**AGENDA
FARRAGUT MUNICIPAL PLANNING COMMISSION**

**October 18, 2018
7:00 p.m. Farragut Town Hall**

**MINUTES
FARRAGUT MUNICIPAL PLANNING COMMISSION**

September 20, 2018

BUILDING B ROOF PLAN - OPTION 1
 FARRAGUT GATEWAY BUILDING B
 FIRST FARRAGUT DEVELOPMENT, LLC

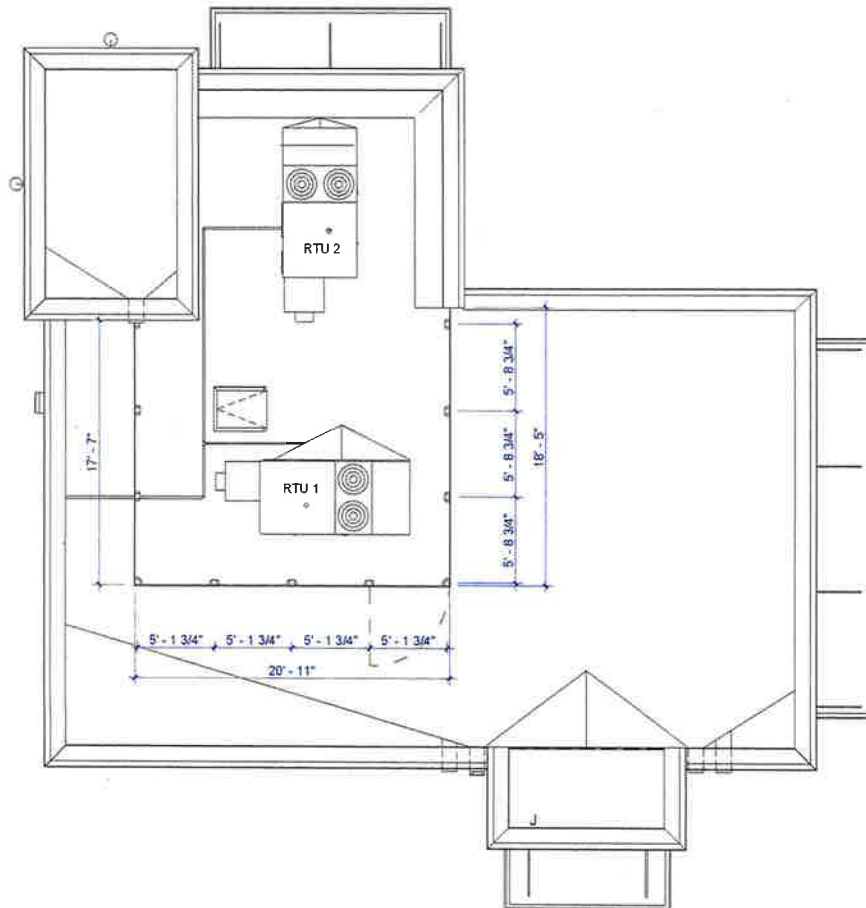
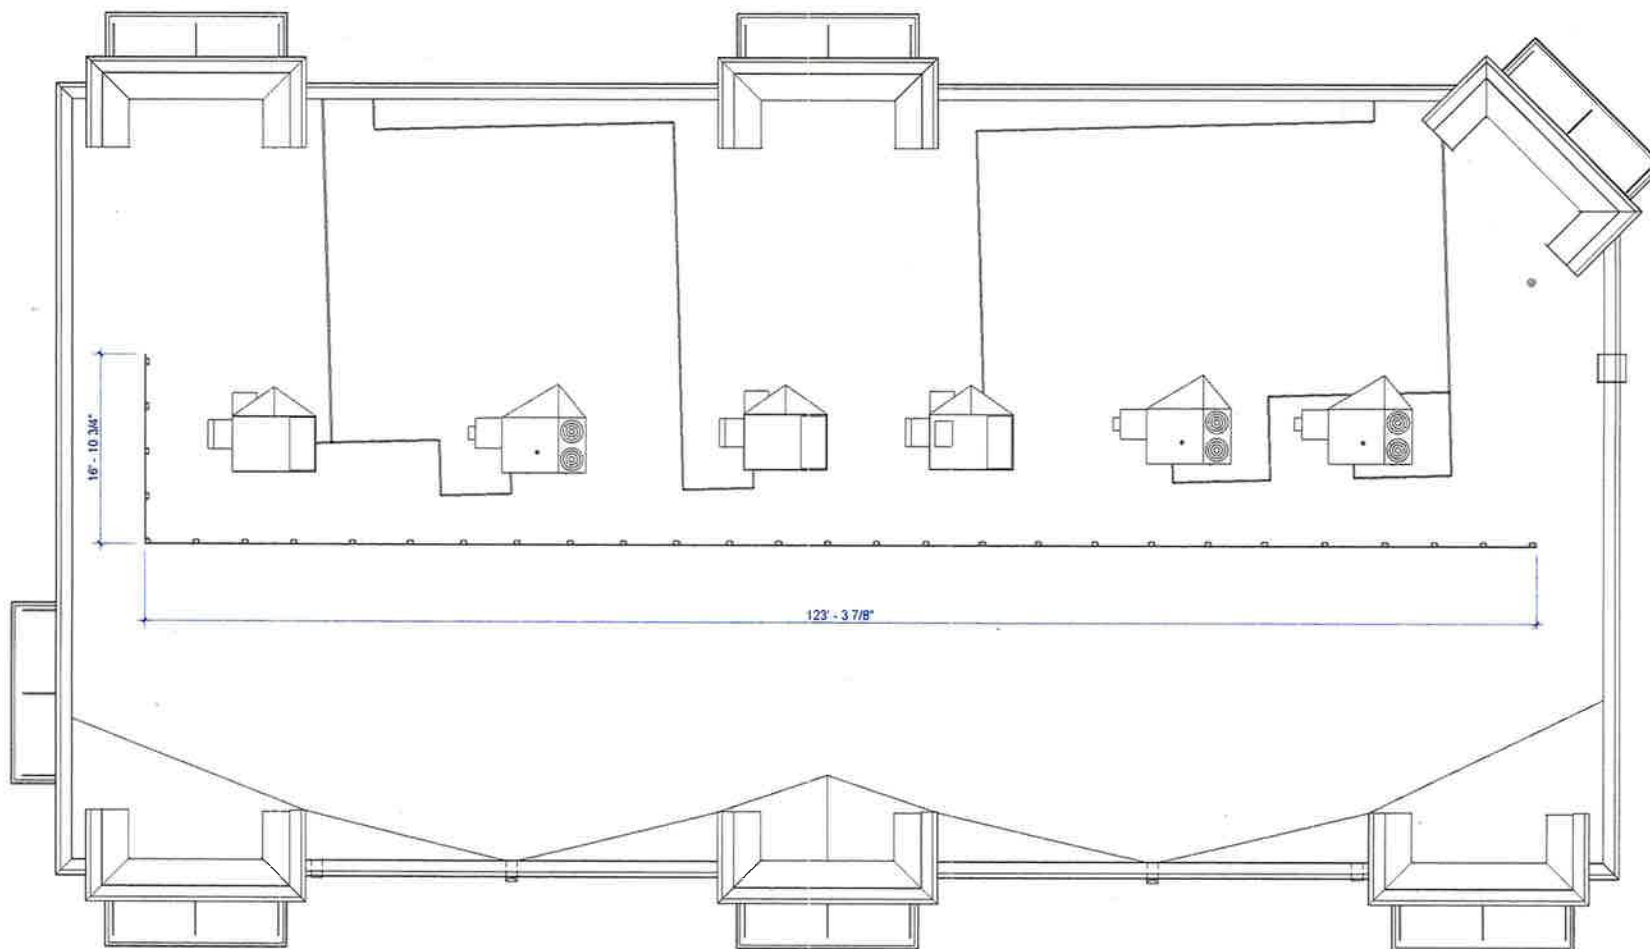
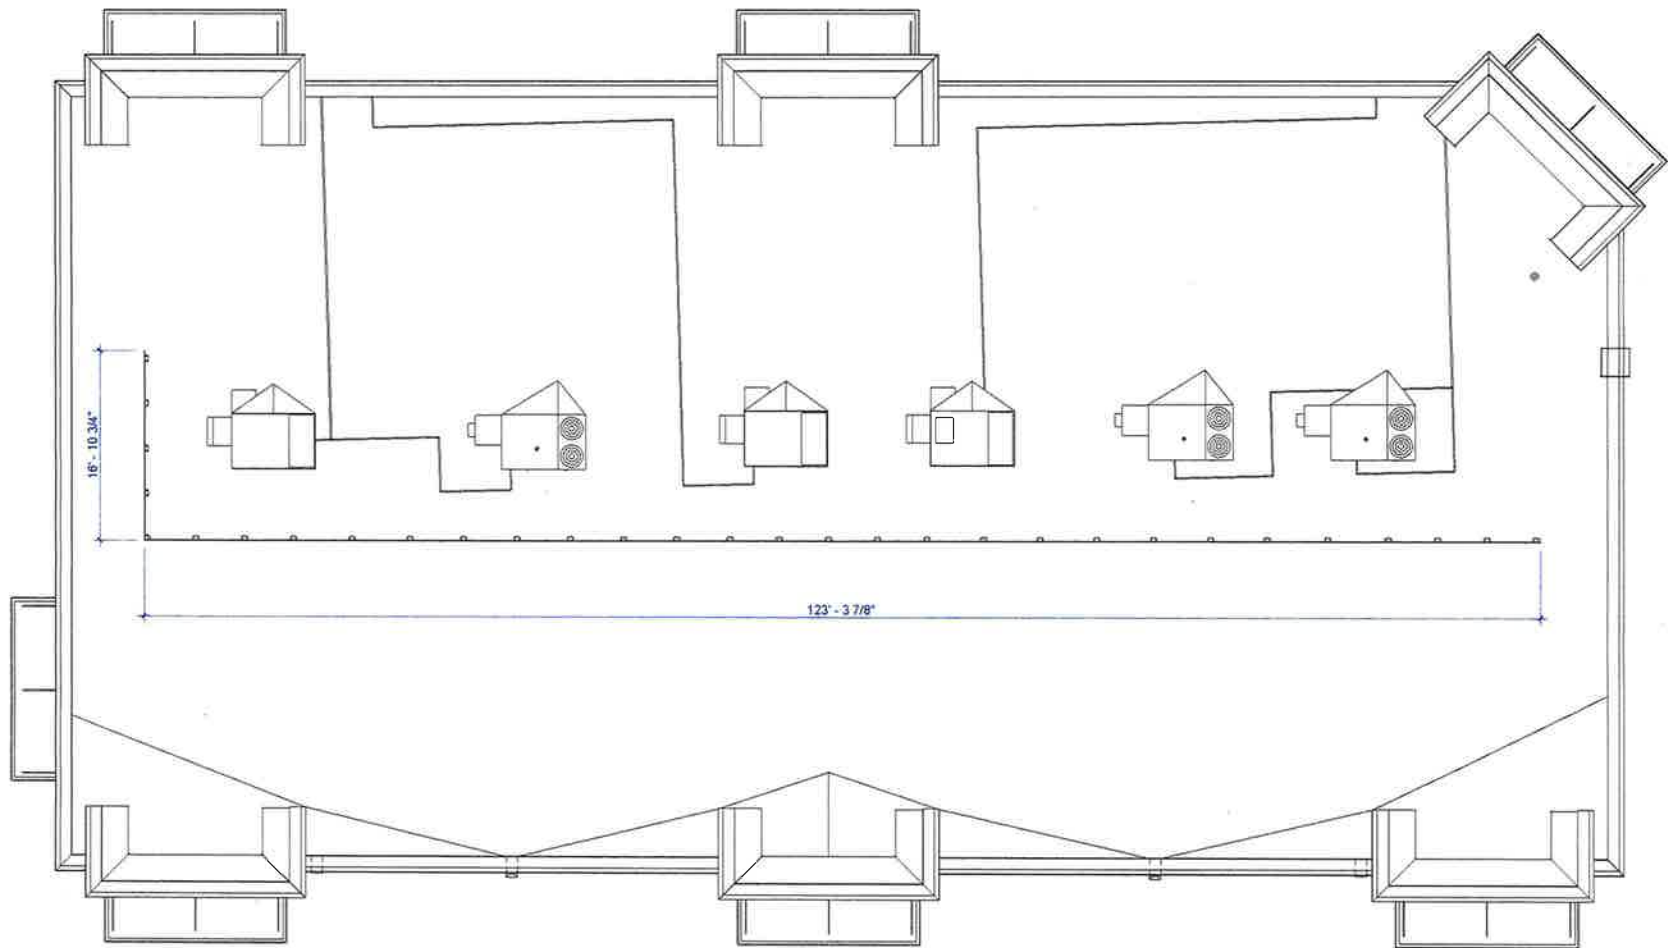
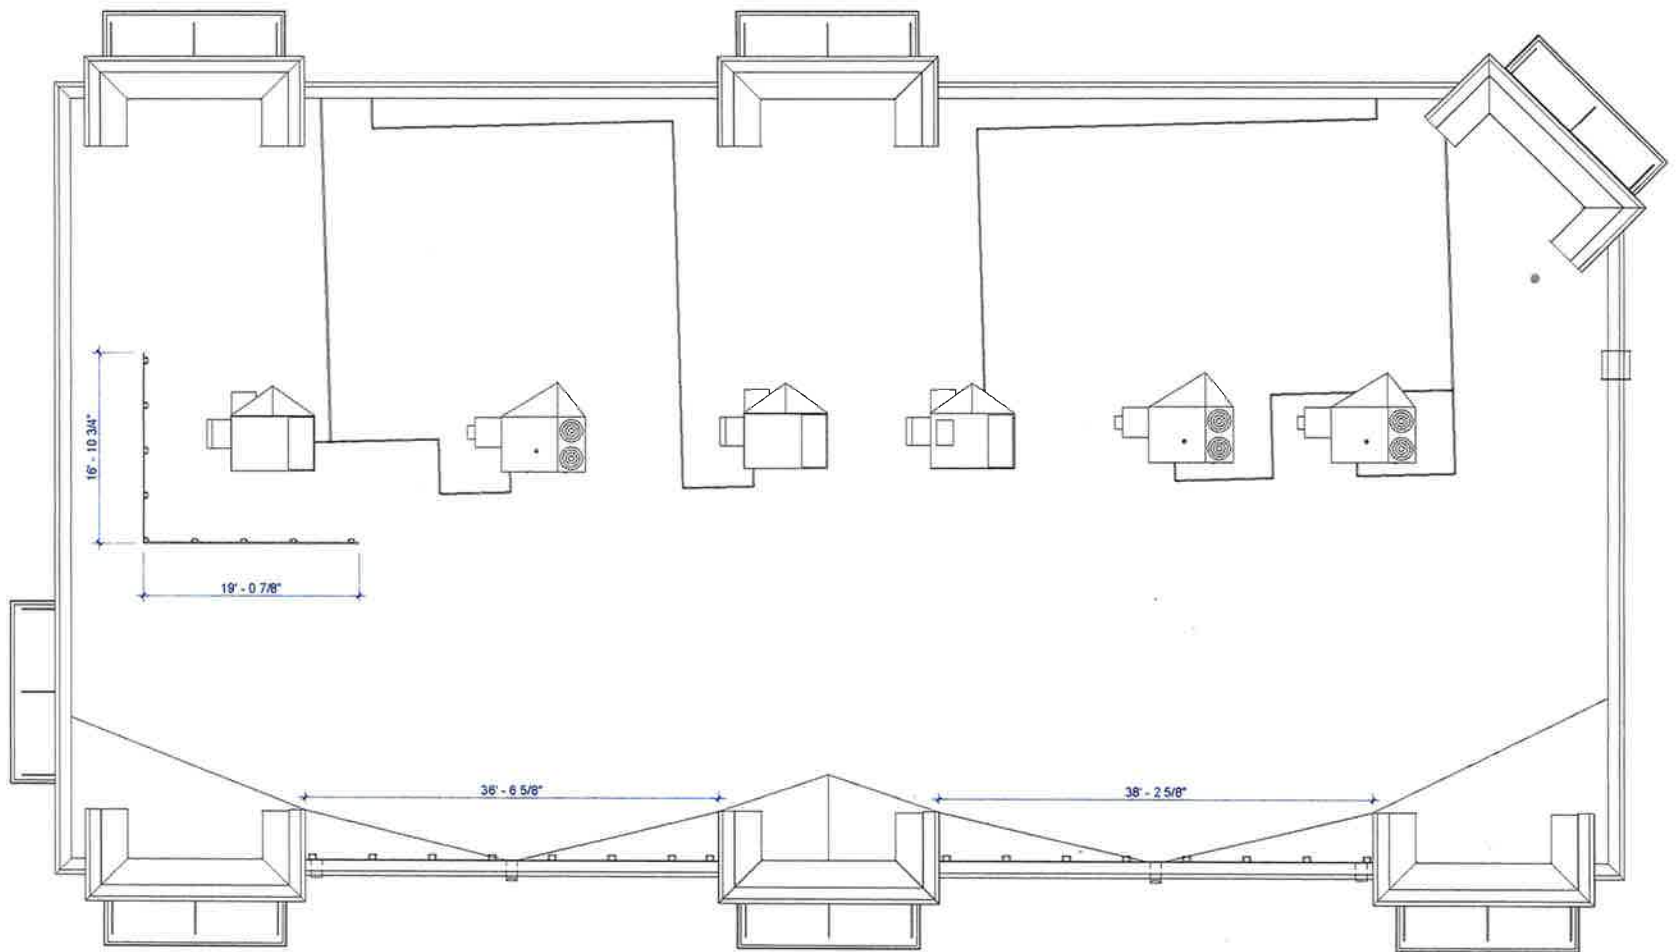
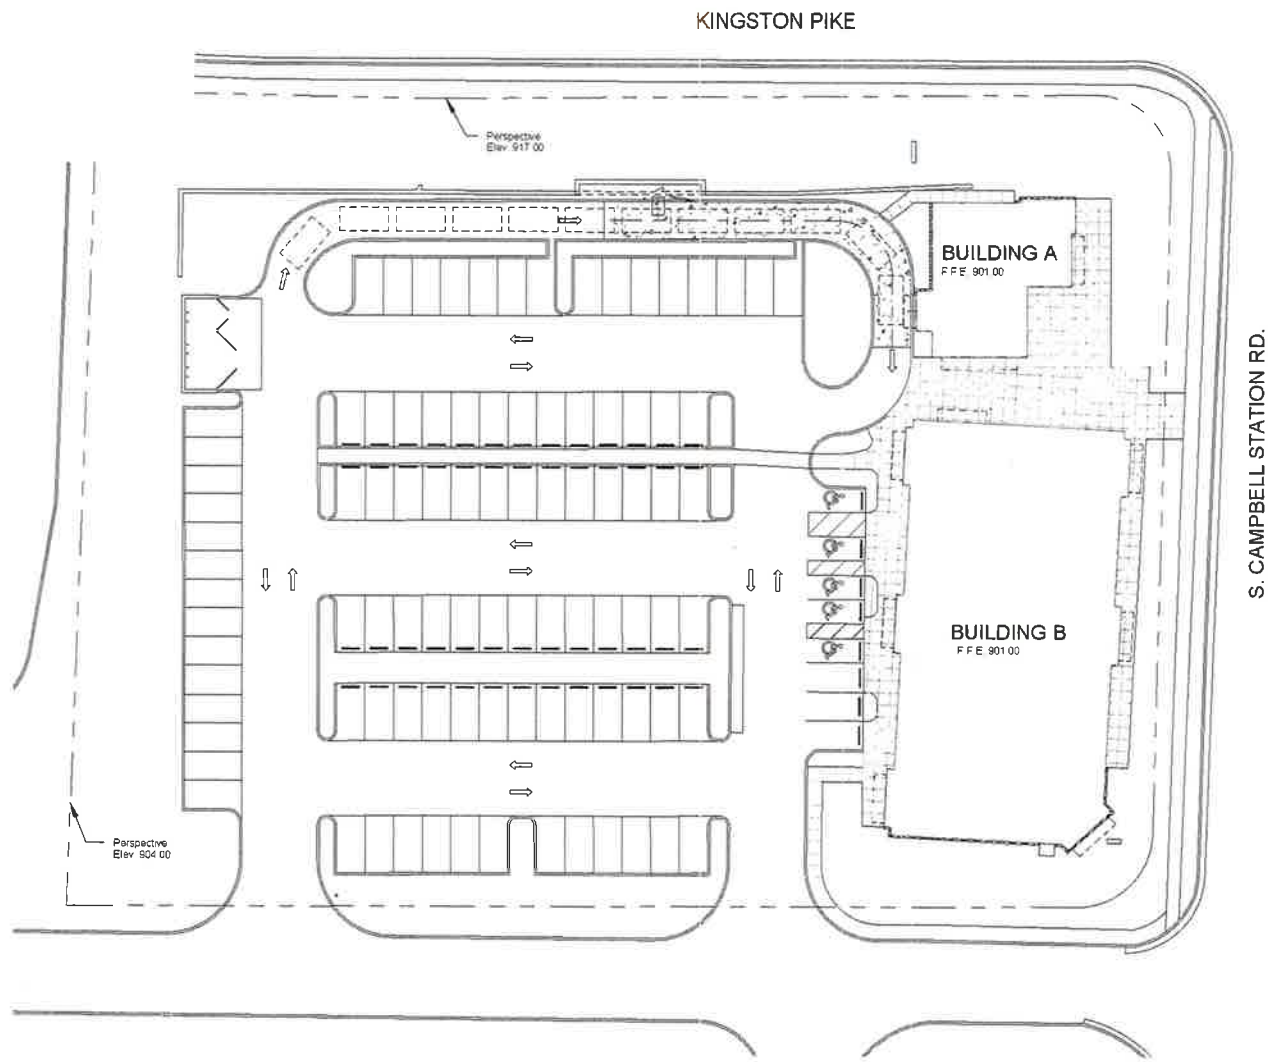
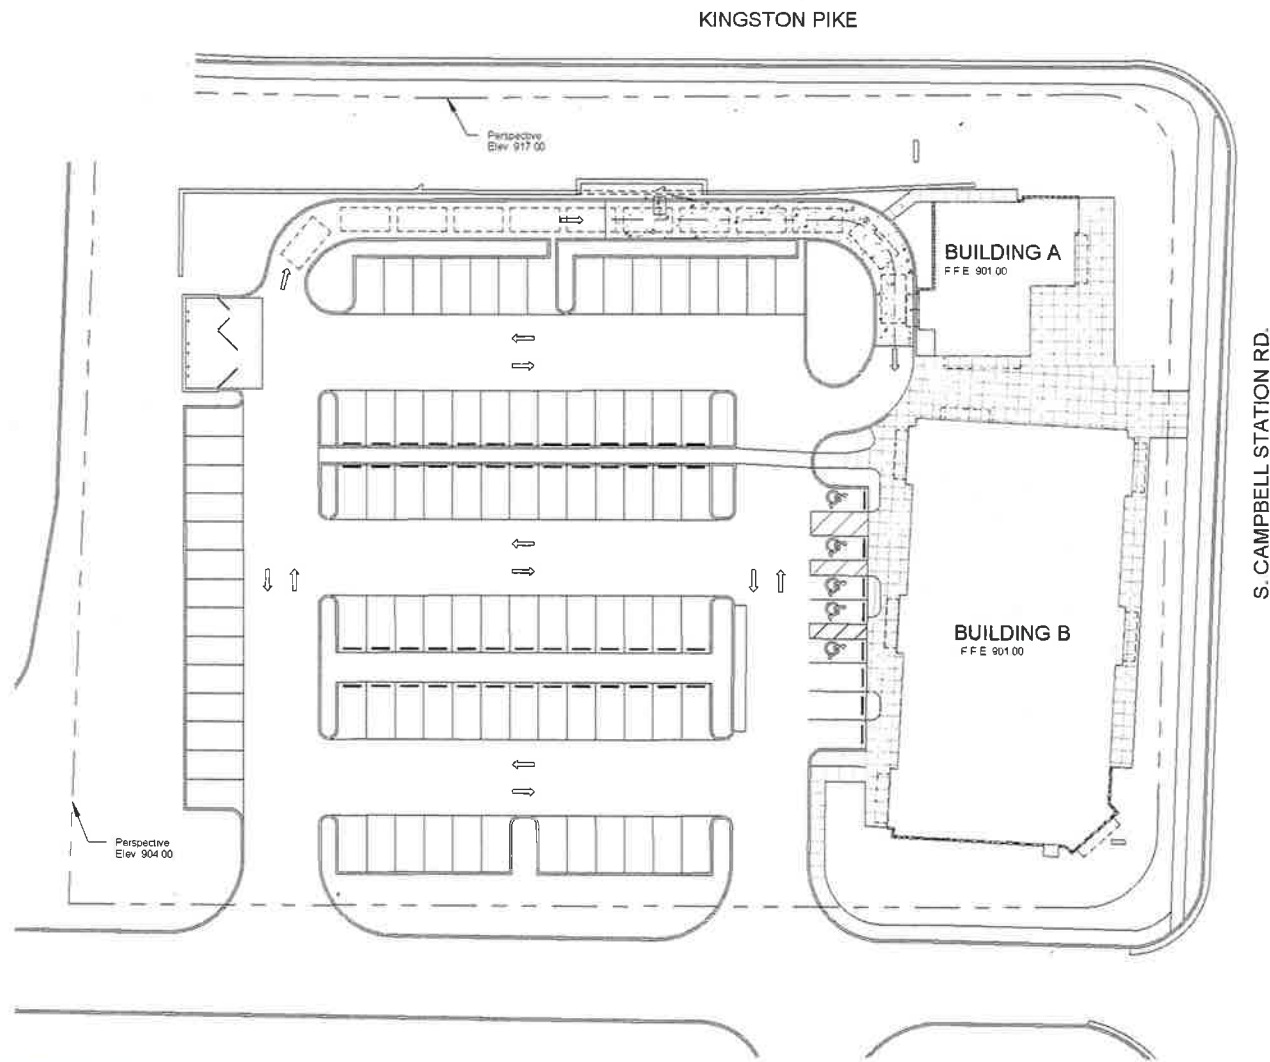
DISCUSSION: Consequently, as part of the site plan review process for the Farragut Gateway project, HVAC screening was specifically accounted for and a note was included on the elevation sheets that the “rooftop units shall be screened by parapets per Town of Farragut requirements.” When construction was initiated, staff notified the owner and architect to please make sure they accounted for the HVAC screening as approved on their site plan submittal. Staff later noted that rooftop units were added to both buildings and were not being adequately screened by the parapets as noted on the plans.

Apparently, during the process of modifying the building elevation heights, an error was made in the sight lines that did not properly account for the size and placement of the units in relation to the adjusted parapet heights. The applicant advised the Town staff that they would like to request an alternate screening system to address this issue. Since this alternate system would differ from what was presented to and approved by the Planning Commission, staff noted that this would have to be presented to the Commission for their consideration.

RECOMMENDATION: A question for the Commission is whether any of these options would be “architecturally compatible with the building the units are serving.” In the case of Options 1 and 2, the screen material would be colored to be compatible with the buildings but the material itself is not found on either building. In the case of Option 3, the screen material would be colored to be compatible with the metal coping used along the roofline of the buildings and would include material that is very similar to what is found, though to a minor degree, on the buildings. Staff would recommend that the placement of any screen material be offset from the front of the building (similar to Option 1) so as not to compete visually with the front façade of the buildings.

Though an option, construction of additional parapets would be a substantial undertaking and could result in notable structural modifications. This would obviously be an option least desired by the applicant.
